MOM on the TS46 WHG Project

Basic Design Approval

Time: 30 June ~ 1 July, 08

Diagram 1

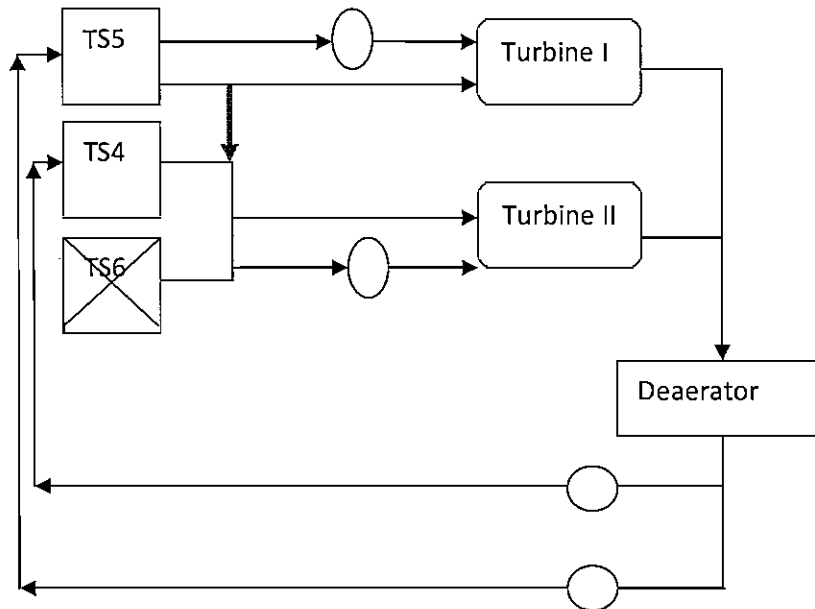
- TS inform SINOMA-EC to design the control system to control pump by using level control for both Phase I and Phase II (the cable need supplied by STS). According to Appendix2

In case TS6 shutdown maintenance.

Diagram 2

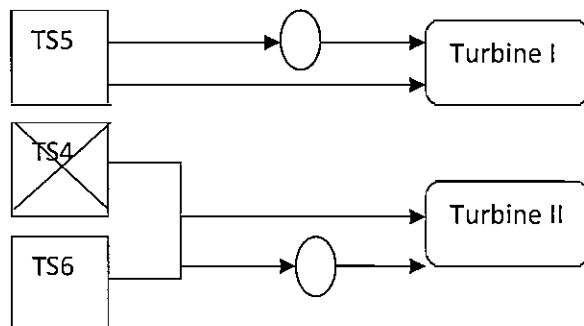
In case TS4 shutdown maintenance.
